Fame Sweaters Ltd. SS Sweaters Ltd.

Holding-124,Darail, Sataish bazar, Tongi; Gazipur, Dhaka
(23.91601N, 90.36467E)

05 March 2014

Observations

Column layout

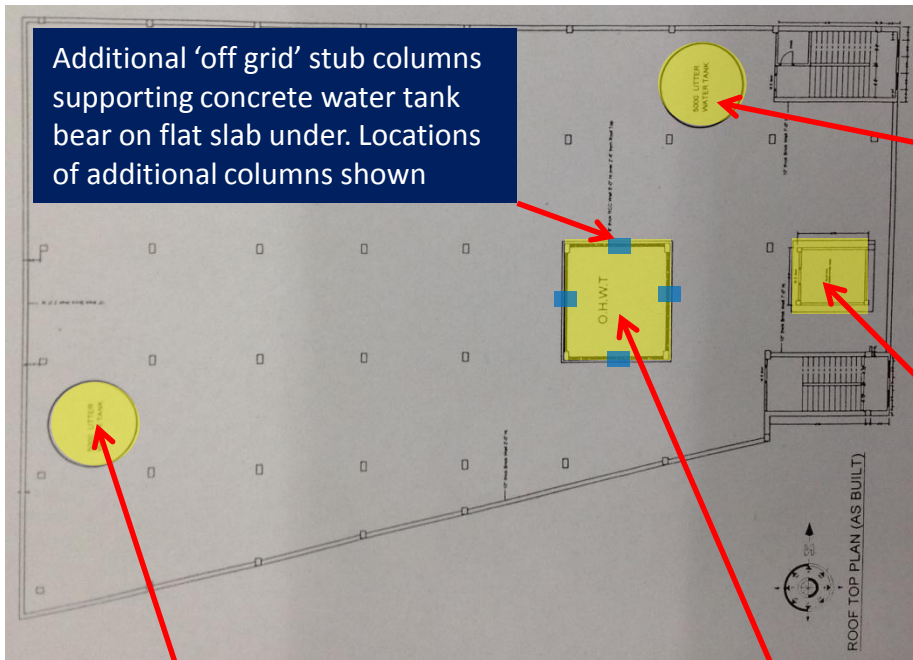
Columns at 2nd floor appear to be stressed in excess of normal design limits

Cursory calculations indicate that the working stress in internal and perimeter columns is at a high level at ground floor level and 1st floor. Remedial works, designed by others, are on-going at ground and 1st floor level to strengthen columns.

Cursory calculations indicate that columns at 2nd floor level are also stressed above normal design levels.

Building Engineer is to perform detailed calculations based on as constructed dimensions and concrete tests to prove column size and (if required) :

- Reduce loads by vacating floors and removing additional structures
- Reinforce columns

High Loading on Roof

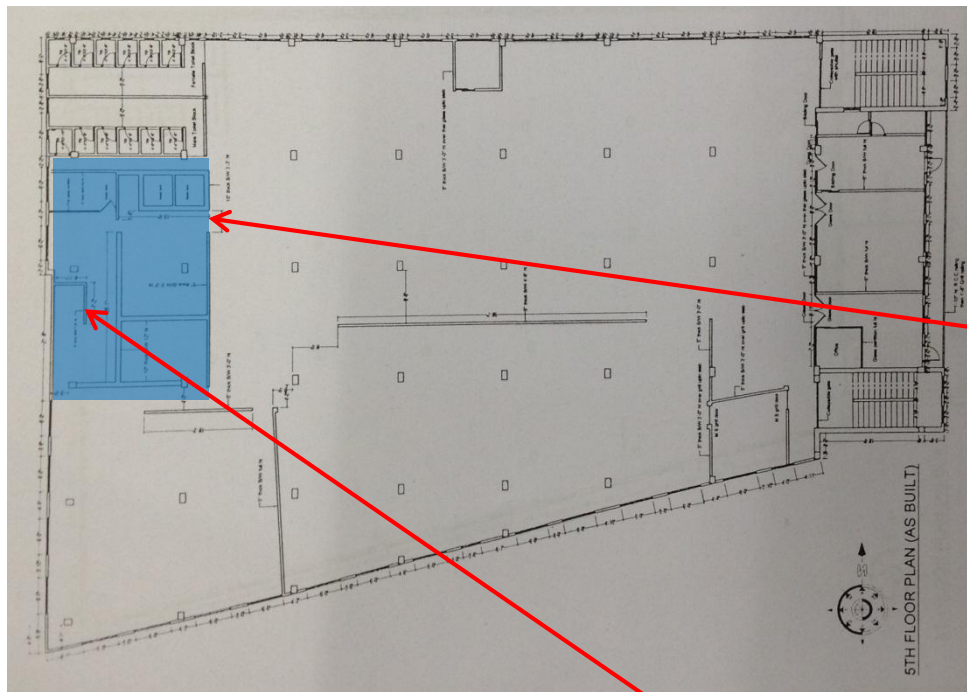
Structural adequacy of concrete roof slab and columns to support antenna house, plastic water tanks and concrete water tank

Additional 'off grid' stub columns supporting concrete water tank bear on flat slab under. Locations of additional columns shown

Building Engineer to check that concrete roof slab and columns have been designed to support loads from Antenna house and water tanks.

Dryer Equipment Loading on 5th Floor

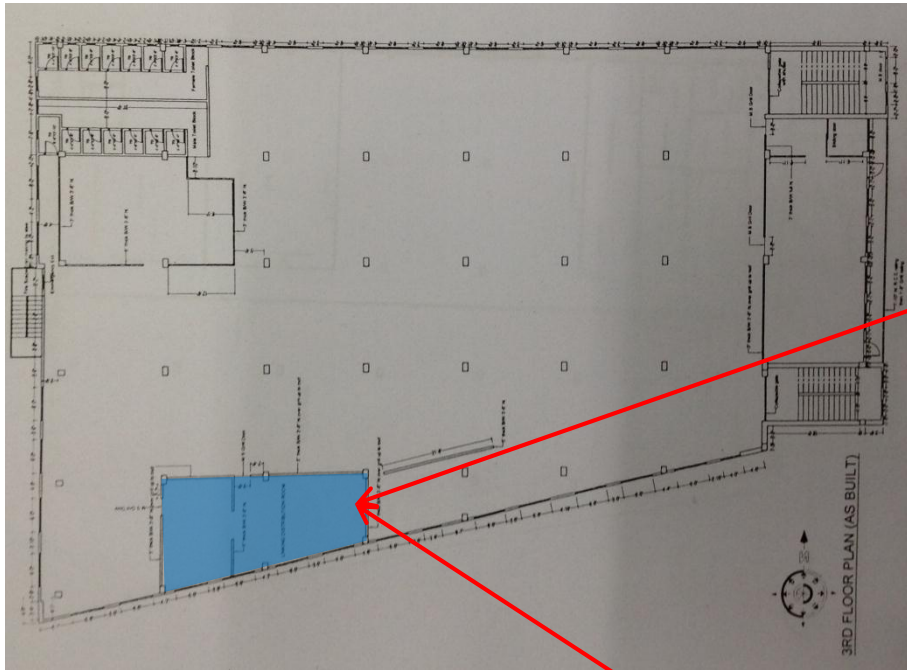
High loading due to dryers,
concrete plinth and concrete
water tank in area shown

Capacity of concrete beams
and floor slab to be confirmed
by Building Engineer

Knitting Distribution Loads on 2nd and 3rd Floor

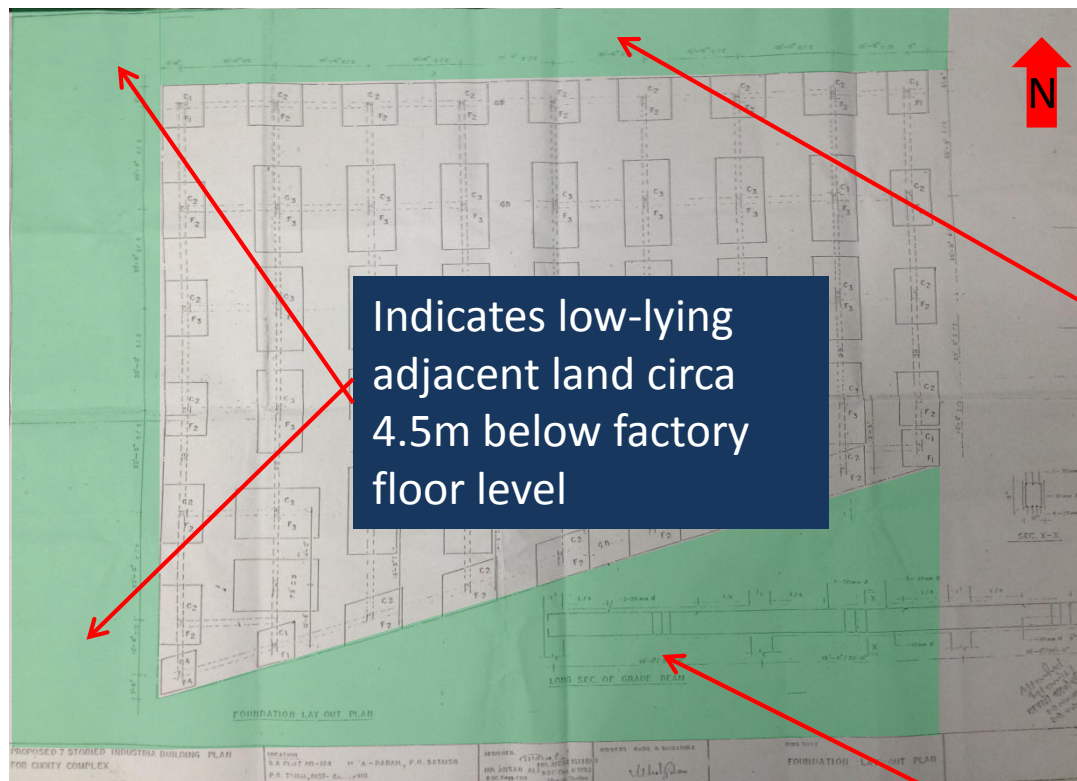
Loading due to storage of garments in the knitting distribution area

Capacity of concrete beams and floor slab to be confirmed by Building Engineer

Pad Foundations Load Spread

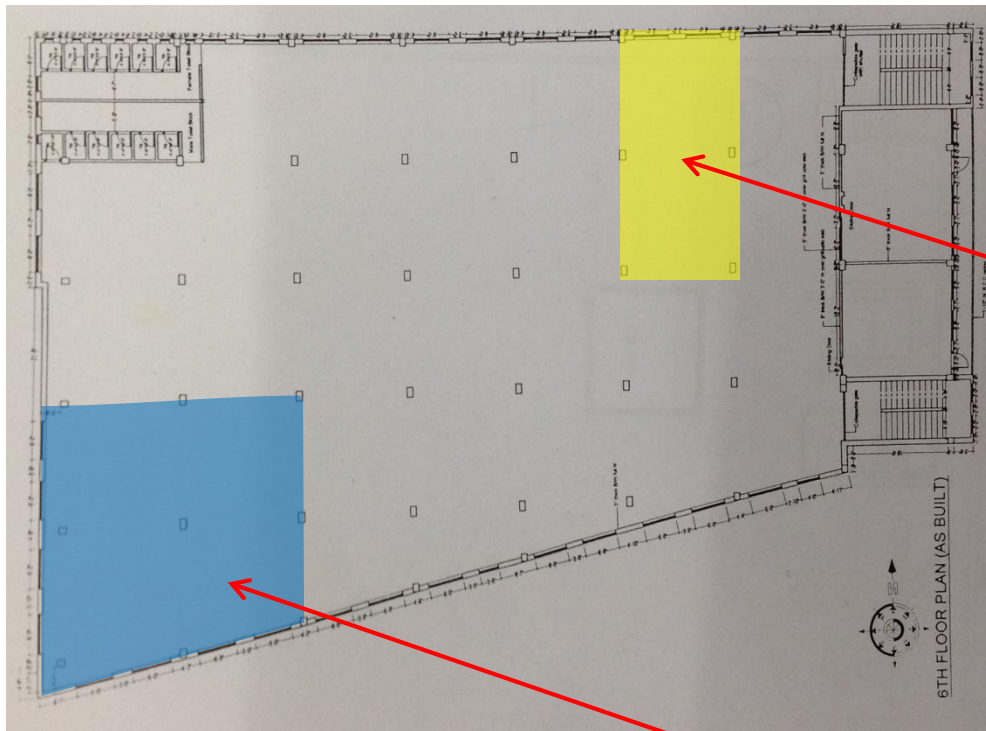
Confirmation required that perimeter column foundations are at an appropriate depth to ensure load distribution

Level of perimeter pad foundations to be confirmed by Building Engineer - at sufficient depth below ground level to ensure adequate load distribution due to difference in level between ground floor and adjacent land

Cracks in Soffit of Flat Slab

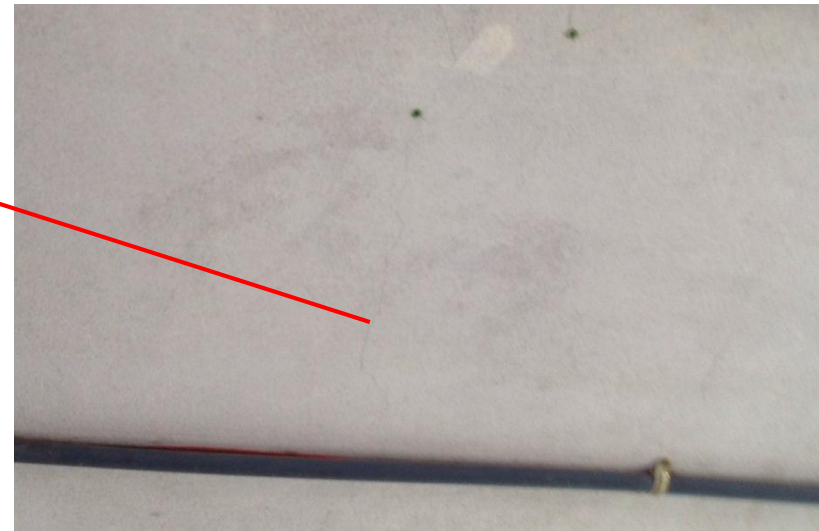
Cracking in soffit of flat slab to be reviewed by removing plaster to confirm that cracks do not extend into structure.

Building Engineer to confirm flat slab imposed design load capacity.

External steel stairs design check

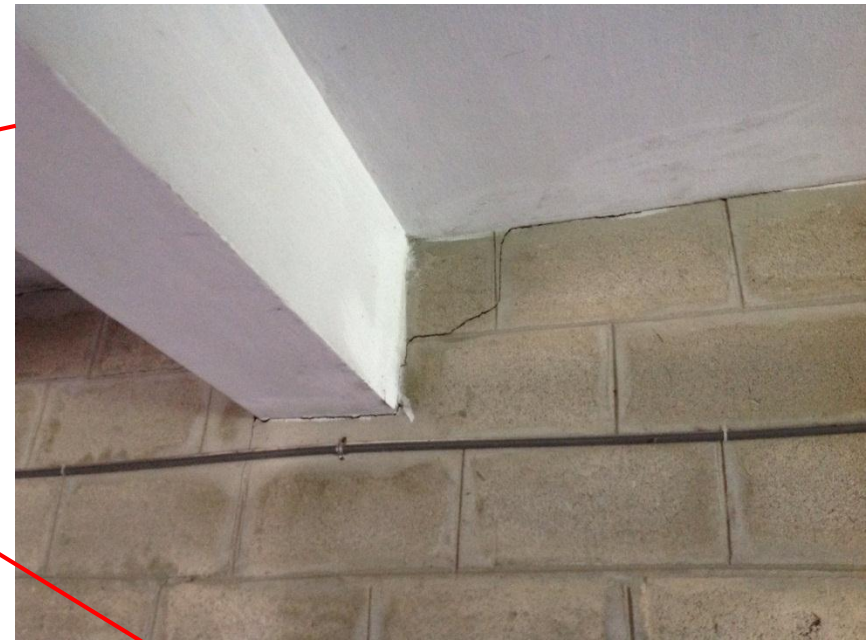
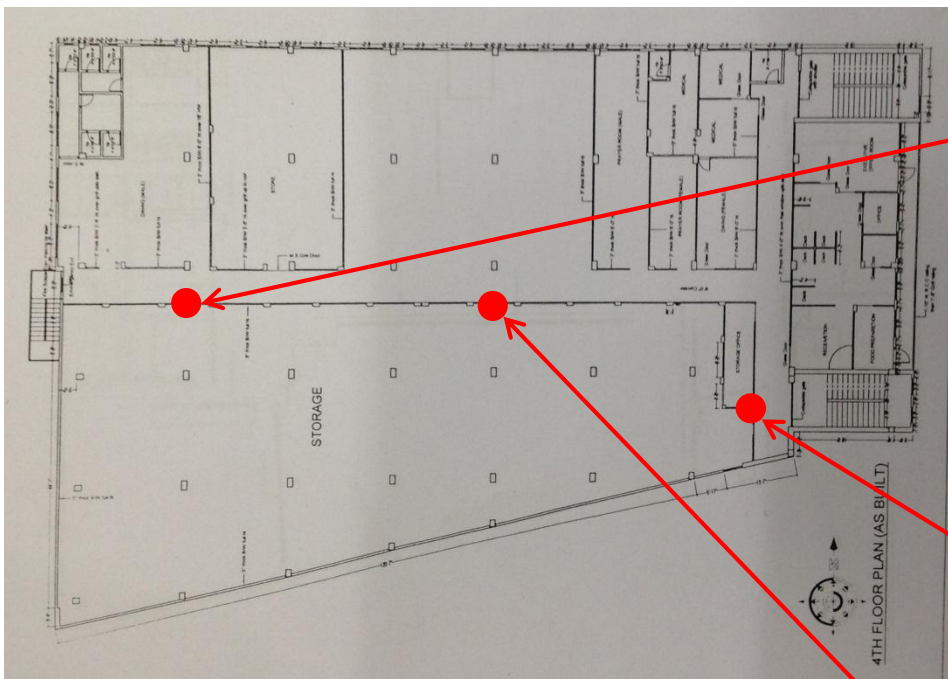
Difference in ground levels – 4.5m

Design of external steel stairs to be checked by Building Engineer for crowd loading.

Level of stair foundations to be confirmed to be at sufficient depth below ground level to ensure adequate load distribution due to difference in level between ground floor and adjacent land.

Cracks in brickwork 4th Floor

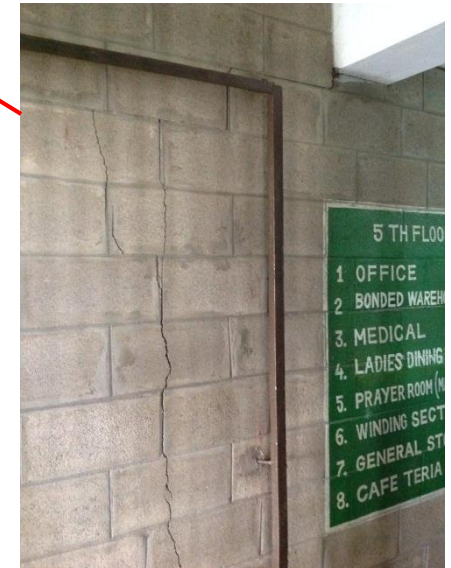
Evidence of cracking in brickwork partitions on 4th floor
